**UNITED STATES OF AMERICA
DEPARTMENT OF ENERGY
FEDERAL ENERGY REGULATORY COMMISSION**

IN THE MATTERS OF)	
)	
Jordan Cove Energy Project, L.P.)	Docket CP17-495-0000
)	
Pacific Connector Gas Pipeline, L.P.)	Docket CP17-494-0000
)

The Western Environmental Law Center, Sierra Club, Greater Good Oregon, Pipeline Awareness Southern Oregon, Oregon Shores Conservation Coalition, Trout Unlimited, Center for Biological Diversity, Oregon Wild, Oregon Coast Alliance, Oregon Physicians for Social Responsibility, Umpqua Watersheds, Inc., OPAL Environmental Justice Oregon, Honor the Earth, 350 Corvallis, Columbia Riverkeeper, Friends of Living Oregon Waters (FLOW), Oregon Women's Land Trust, Earthworks, Hair on Fire Oregon, Rogue Climate, Oregon Women’s Land Trust, Cascadia Wildlands, Snattlerake Hills, LLC, Waterkeeper Alliance, Great Old Broads for Wilderness, Cascade Volcanoes Chapter, Pacific Coast Federation of Fishermen’s Associations, Institute for Fisheries Resources, Rogue Riverkeeper, Beyond Toxics, and affected landowners Deb Evans and Ron Schaaf submit these comments on the Draft Environmental Impact Statement (DEIS) for the Jordan Cove Energy and Pacific Connector Gas Pipeline Pro

Figure 10: Pipeline Parallel to and Crossing Spencer Creek and crossing **Clover Creek**, near Milepost 177

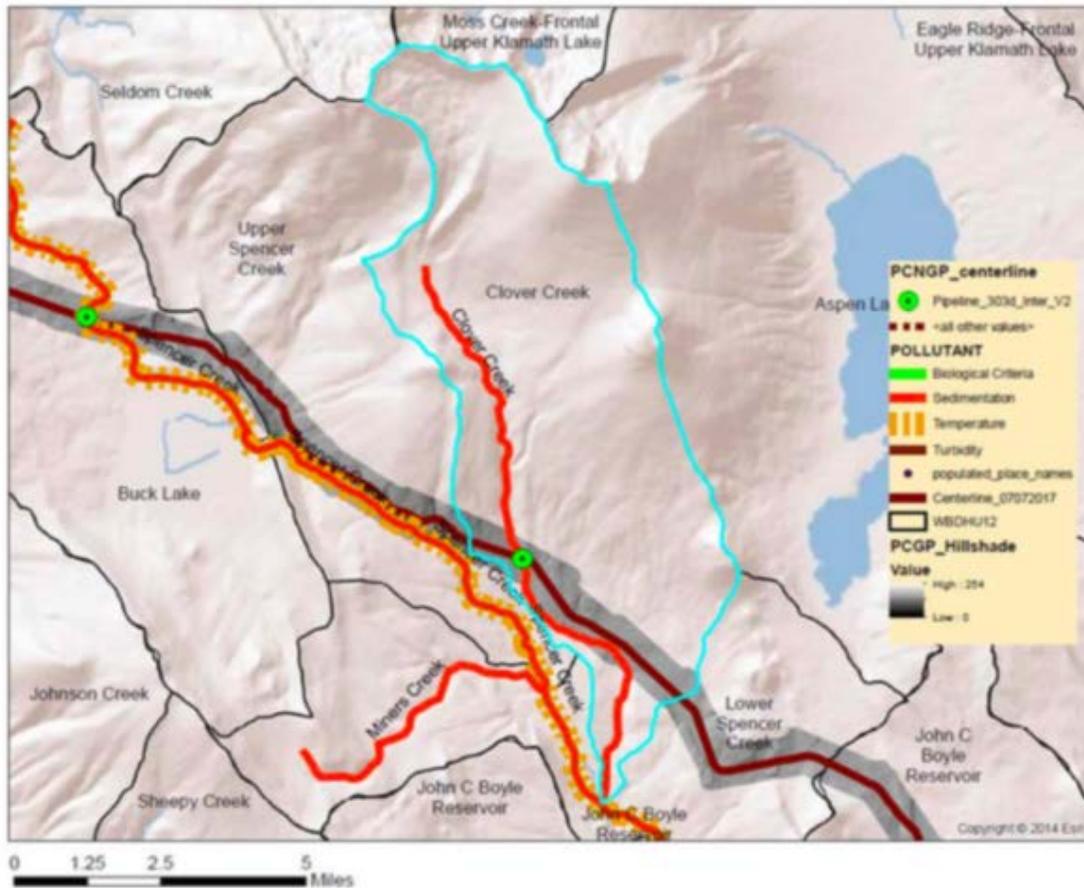
Figure 10 shows one of several examples of the permanent ROW crossing or paralleling streams on the 303(d) list for sediment or crossing streams discharging to these sediment-listed streams. Based on its proposed conceptual approach for operating the ROW, the permanent ROW has the potential to discharge sediment at stream crossings. Ongoing increases in sediment loading to a waterbody that is listed on the 303(d) list for sediment is not allowed without either a TMDL allocation, or an implementation plan showing that there will be no increase in loading. OAR 340-41-0004(7) (“Water quality limited waters may not be further degraded except in accordance with paragraphs (9)(a)(B), (C) and (D) of this rule.”) JCEP has not provided the analyses for the discharges that would occur at each slope breaker for each stream crossing. In addition, JCEP has not performed an analysis to demonstrate that the herbaceous area in the permanent ROW between the last slope breaker and stream is an effective BMP by itself and would not contribute to or cause a water quality standard violation, particularly near waterbodies that are not meeting standards for sediment. As noted in DEQ’s September 7 (Page 11 of 15 of, Attachment B) and December 2018 (Page 66 – 68 of Attachment A) information requests, DEQ requested that JCEP evaluate the efficacy of these proposed BMPs using modeling. JCEP has not provided DEQ with this evaluation of the water quality impacts from this slope breaker discharge nor has it provided DEQ with the analysis of the proposed treatment for the discharge from slope breakers immediately upslope of a stream.³⁵⁵
